FINAL PLAT
PINE MEADOW SECOND ADDITION
AN ADDITION TO WICHITA, SEDGWICK COUNTY, KANSAS

RE: SUB 2001-98 -- One-Step Final of Pine Meadow Second Addition

STAFF REPORT
(One-Step Final Plat Approved 9/27/01)

CASE NUMBER: SUB 2001-98 -- PINE MEADOW SECOND ADDITION

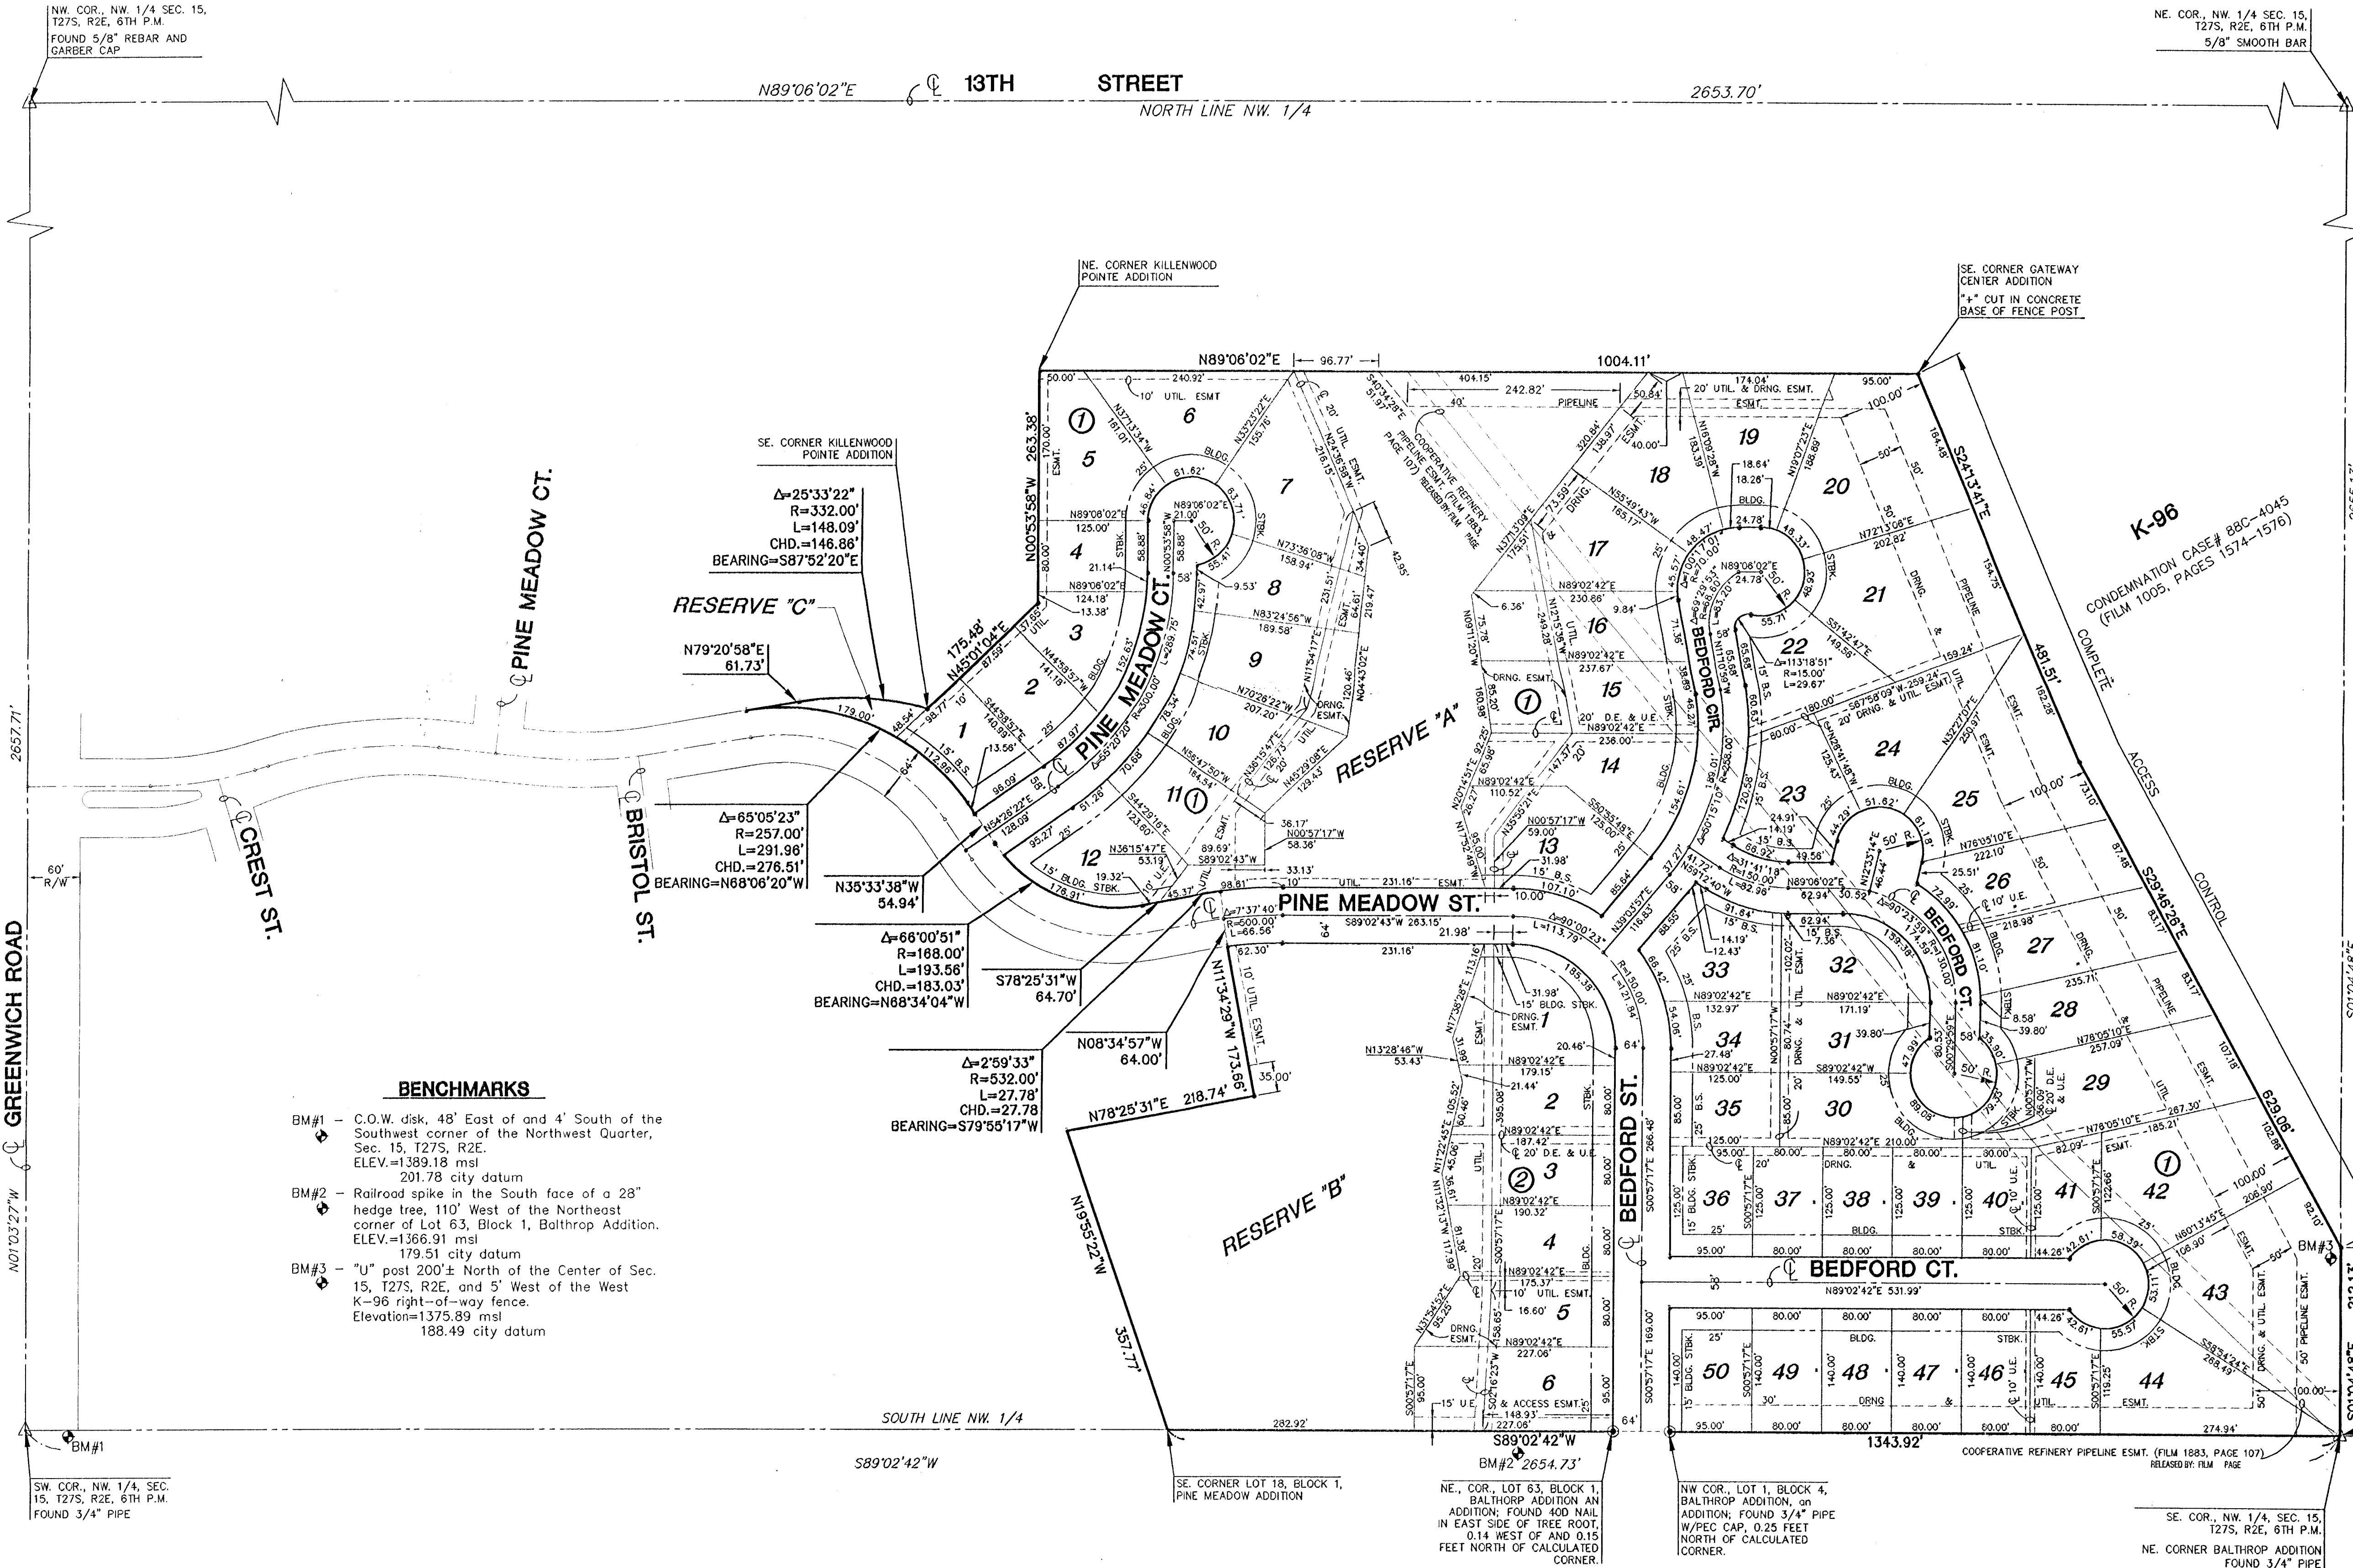
- A. The applicant shall guarantee the extension of sanitary sewer. This guarantee shall be with the City for service through the Four Mile Creek sanitary sewer system.

- B. The applicant shall guarantee the extension of City water to serve the lots being platted.
- C. If improvements are guaranteed by petition, a notarized certificate listing the petitions shall be submitted to the Planning department for recording.

- D. **City Engineering** needs to comment on the status of the applicant's drainage plan. *The drainage plan is approved.*
- E. The Applicant shall guarantee the paving of the proposed streets. The guarantee shall also provide for sidewalks on one side of Pine Meadow/Bedford.

- F. The applicant shall submit a covenant which provides for four (4) off-street parking spaces per dwelling unit on each lot which abuts a 58-foot street. The covenant shall inventory the affected lots by lot and block number and shall state that the covenant runs with the land and is binding on future owners and assigns.

- G. The applicant shall submit a copy of the instrument which establishes the pipeline easements on the property, which verifies that the easements shown are sufficient and that utilities may be located adjacent to and within the easements.

- H. The applicant's agent shall determine any setback requirements for the pipelines by researching the text of the pipeline agreements. If a setback from the pipeline easements is provided for in the pipeline easement agreements, it shall be indicated on the face of the plat.

- I. The recording information for all pipeline easements shall be indicated on the face of the plat.
- J. The Subdivision regulations discourage the inclusion of pipeline easements within the perimeter of residential lots. It is recommended that the pipeline crossing Block 1 be included within a Reserve. In the alternative, a restrictive covenant shall be provided indicating the pipeline easement within the pertinent lots.

- M. The blocks need to be renumbered as the perimeter of the blocks should be bounded by streets.
- N. Approval of this plat will require a waiver of the lot depth to width ratio of the Subdivision Regulations for Lots 9, 13-16, Block 1. The Subdivision Regulations state that the maximum depth of all residential lots shall not exceed 2.5 times the width. **A modification has been approved.**

- O. The **County Fire Department/GIS** needs to comment on the plat's street names. **GIS has requested that Pine Meadow and Pine Meadow Ct be renamed Killenwood and Killenwood Ct.**

- Q. On the final plat tracing, the MAPC signature block needs to reference "J.D. Michaelis, Chair".
- R. The platlor's text shall include language that a drainage plan has been developed for the plat and that all drainage easements, rights-of-way, or reserves shall remain at established grades or as modified with the approval of the applicable City or County Engineer, and unobstructed to allow for the conveyance of stormwater.

- Z. The representatives from the utility companies should be prepared to comment on the need for any additional utility easements to be platted on this property. **KGE and Southwestern Bell have requested additional easements.**
